**OGDEN** ENVIRONMENTAL AND ENERGY SERVICES

June 23, 2000  
Serial No. 00-127

Subject: Comments on Draft Focused Feasibility Study for the Southern Area Alternative at the Metal Bank Site, prepared by CDM Federal and dated May 17, 2000  
Metal Bank Superfund Site  
Ogden Project 87053-0000

**Comments on Focused Feasibility Study  
Southern Area Alternatives  
Metal Bank Superfund Site**

**DRAWINGS**

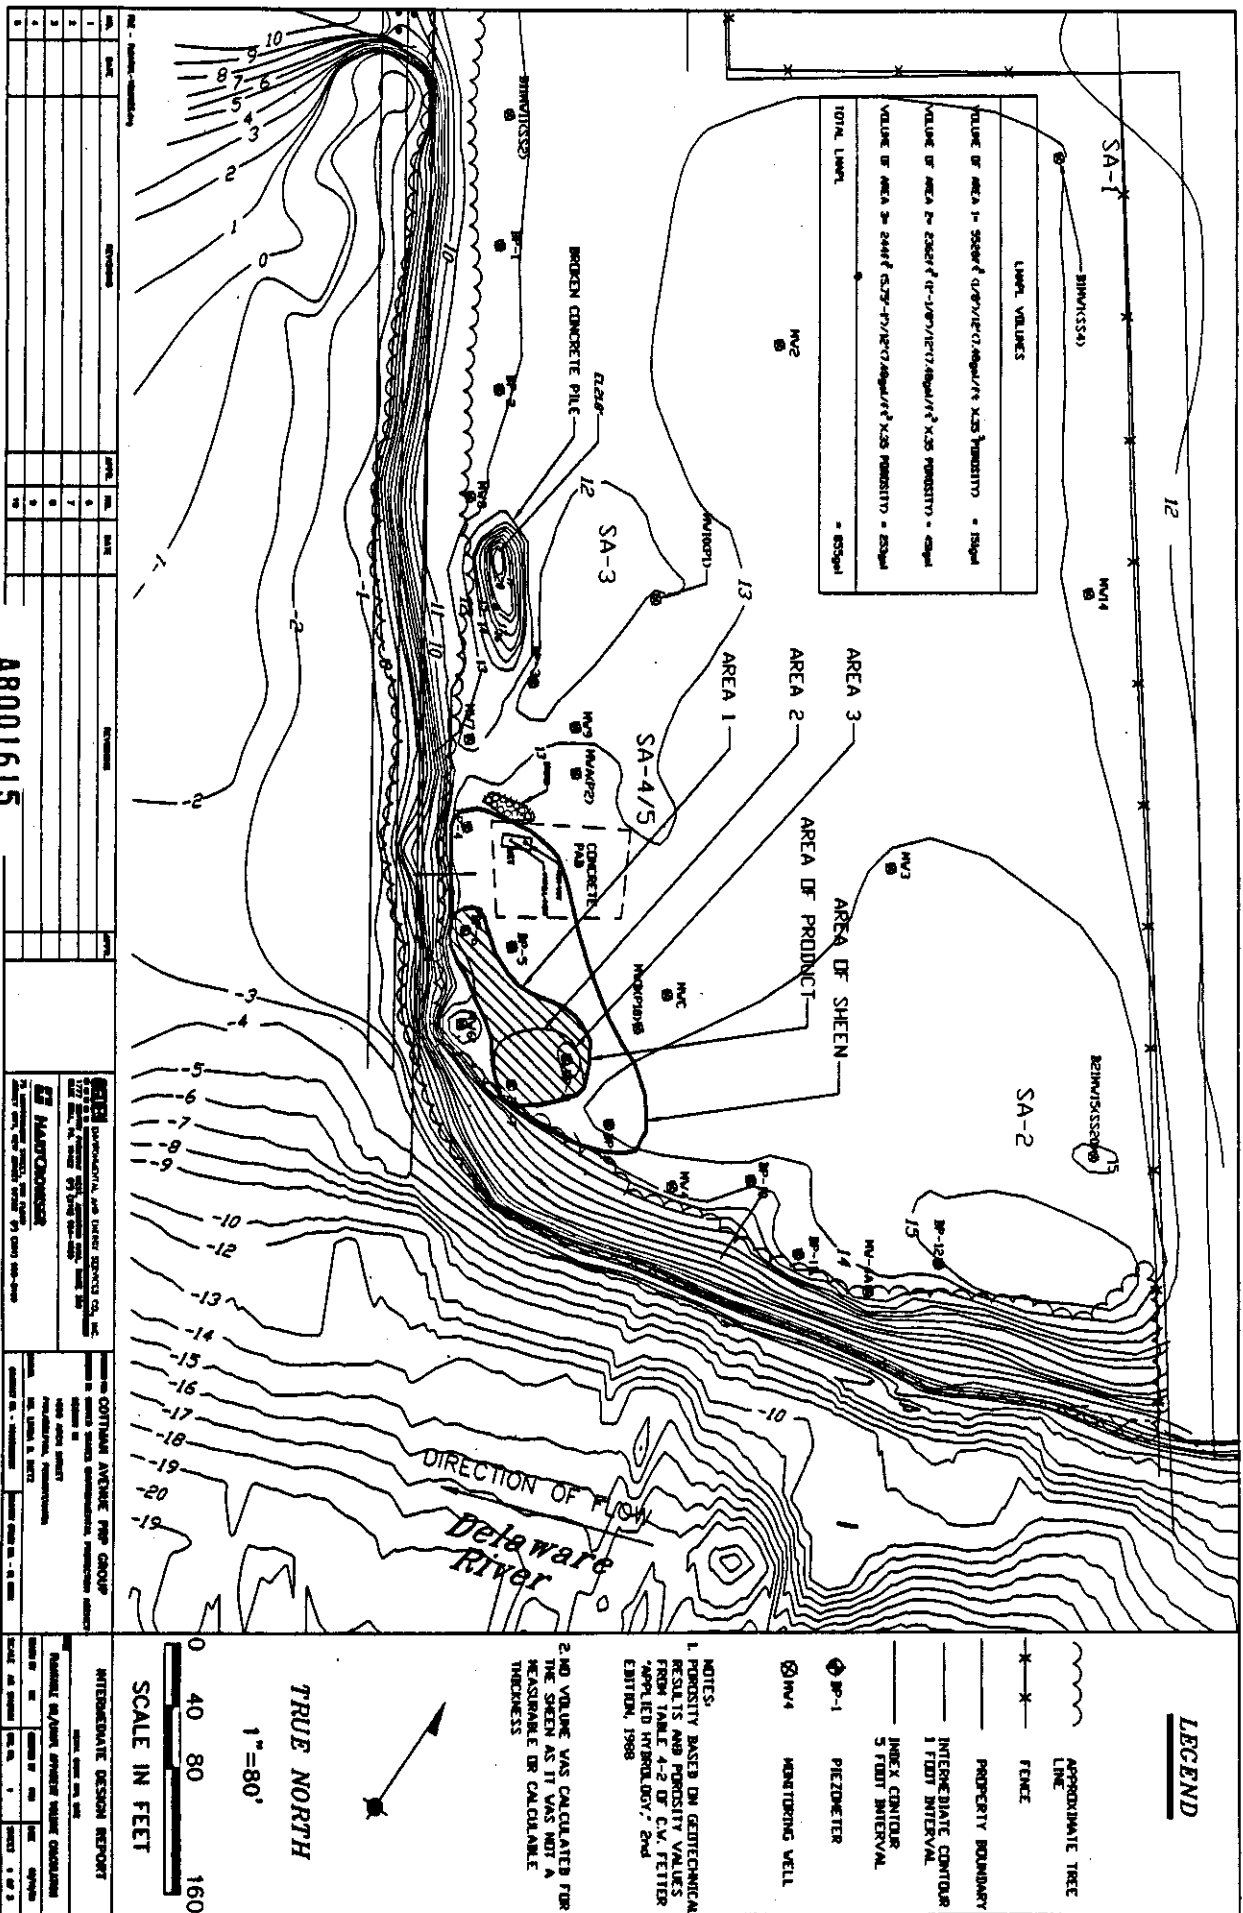
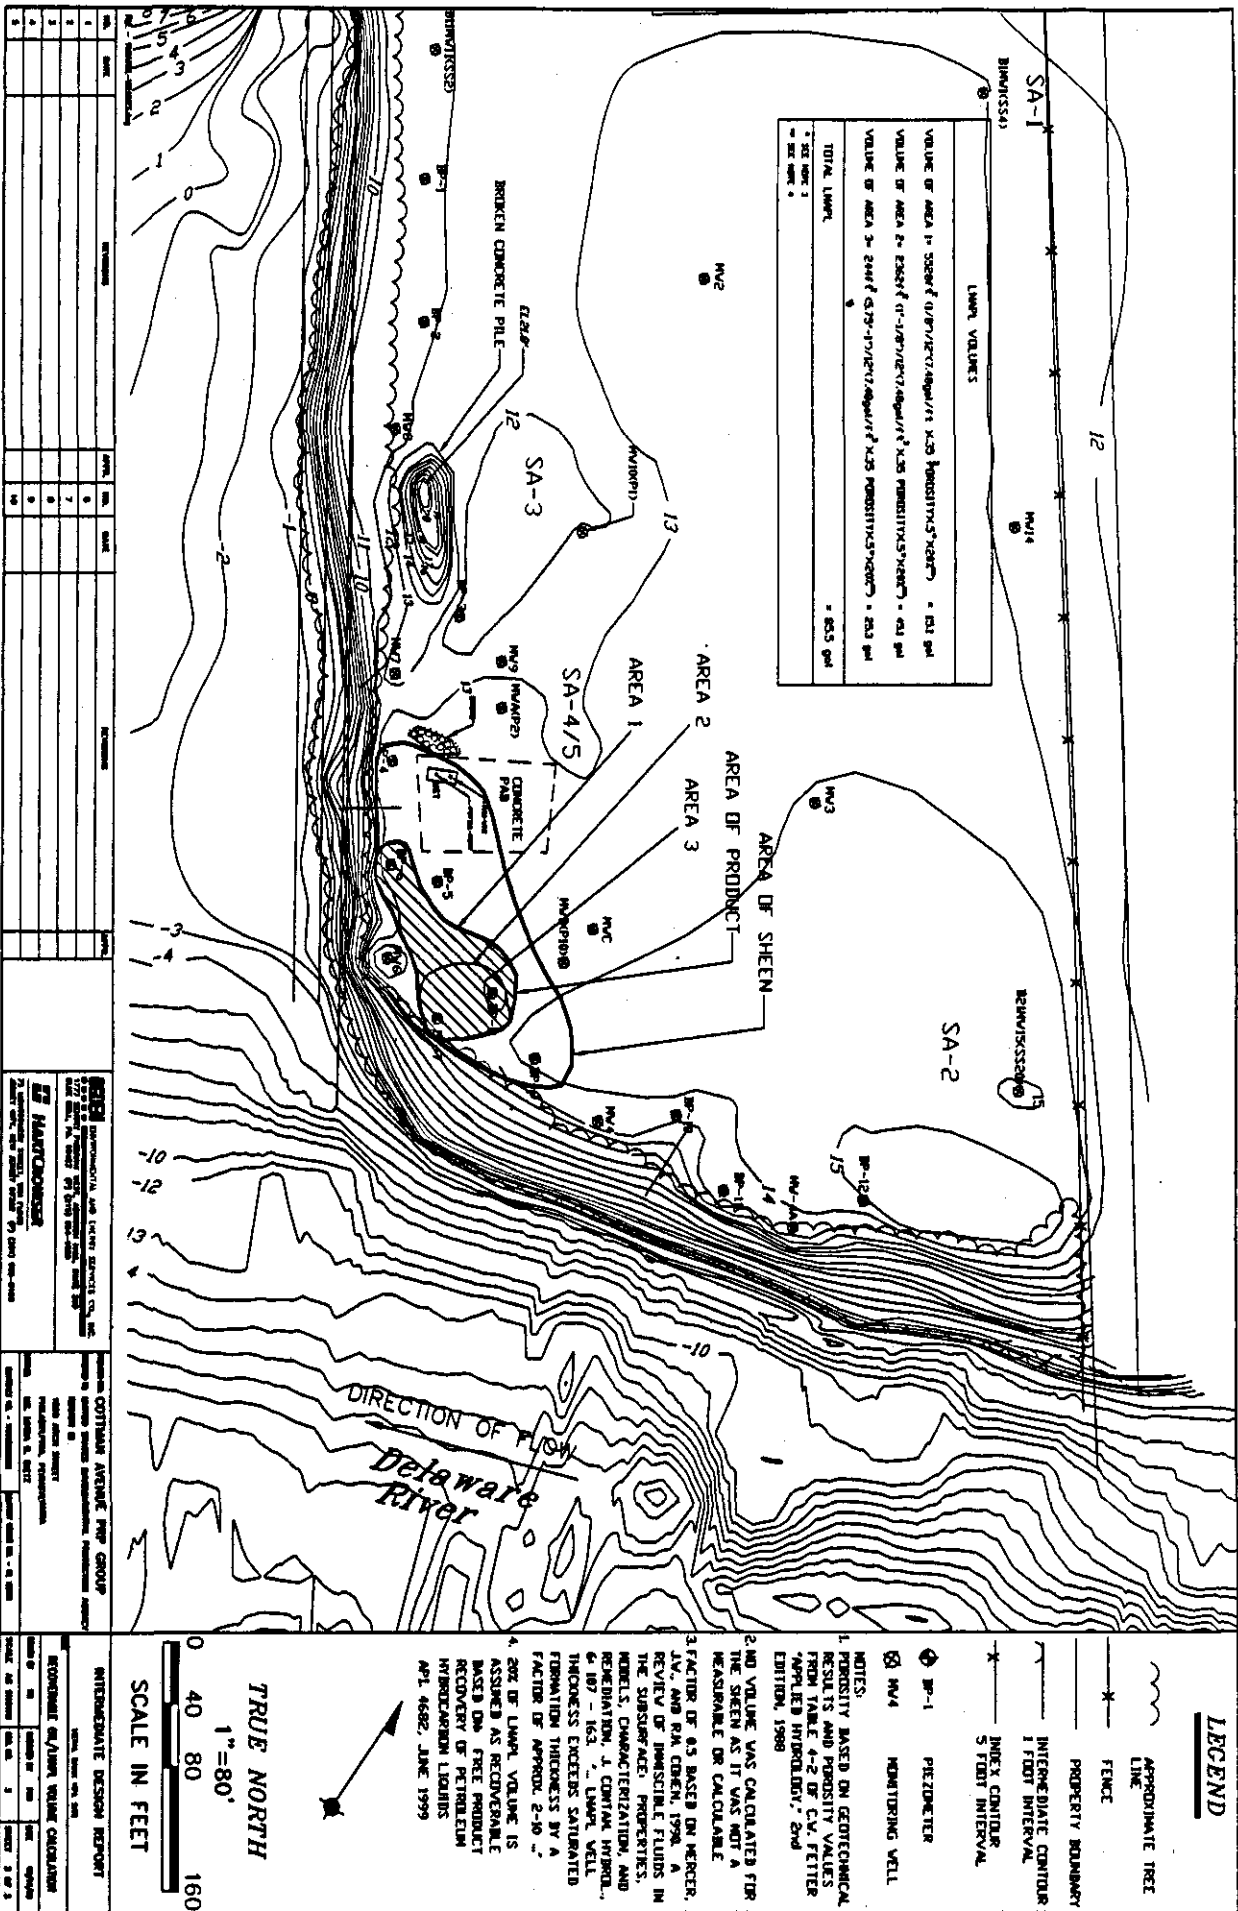
Ogden has included three drawings to demonstrate the volume of LNAPL that is likely to exist at the site.

Drawing 1, "Floatable Oil/LNAPL Apparent Volume Calculation," indicates the volume of LNAPL that would be present based on the (erroneous) assumption that the measured thickness in the wells represents the thickness in the surrounding area, and calculates the volume based on AutoCad areas and the

anticipated porosity of 35 percent. Drawing 2, "Floatable Oil/LNAPL Actual Volume Calculation," indicates the volume of LNAPL likely to be present when dividing by a factor of 2 for the apparent thickness and accumulation in the wells. Drawing 3, "Recoverable Floatable Oil/LNAPL Volume Calculation," indicates the volume of that LNAPL that is likely to be recoverable is less than 100 gallons of LNAPL. This applies an additional 20 percent factor based on the above reference, which indicates only 20 to 30 percent of the LNAPL is typically able to be recovered. The 20 percent factor is appropriate for the residual oil at this site due to the time since the release and the previous recovery operations. Ogden also has included as Attachment 1 a calculation sheet showing the calculated recoverable oil based on the API document.
